**REMARKS**

Docket No.: A0312.70388 US00  
Date: May 16, 2005  
**x05/16/2005**

**In the Drawings**

**FIG. 7**  
(Prior Art)

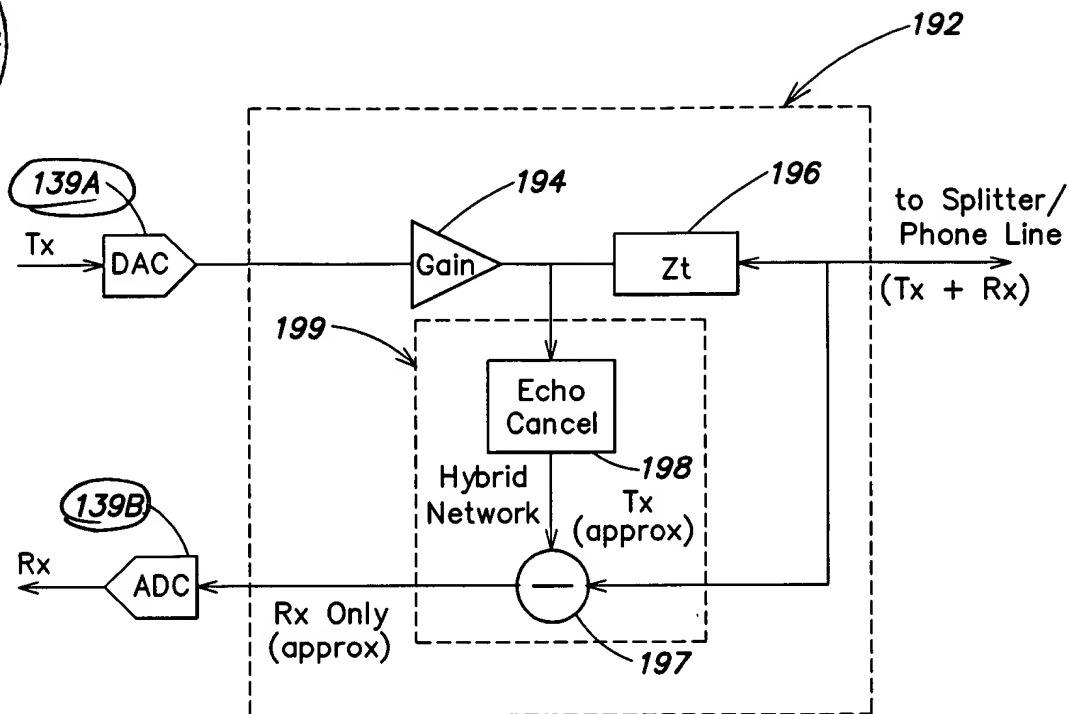
As indicated on the annotated drawing sheets, reference numbers 139A and 139B were added to Figure 7 pursuant to the specification at page 5, line 12. On Figures 15a and 15b, the numbering of curves 440 and 442 was changed to 441 and 443 to avoid double use of those reference numbers (see Fig. 14 b). In Fig. 20A, reference numbers 742, 744 and 746 were changed, respectively, to 743, 745 and 747 to avoid duplicate use of those reference numbers for different components (see elsewhere on the same Fig.). On Fig. 25, reference number 946 was changed to 814b, pursuant to the specification on page 37, line 8. On Fig. 30, the reference numeral for capacitor 1010 was changed to 1011, as the node next to it was also numbered 1010.
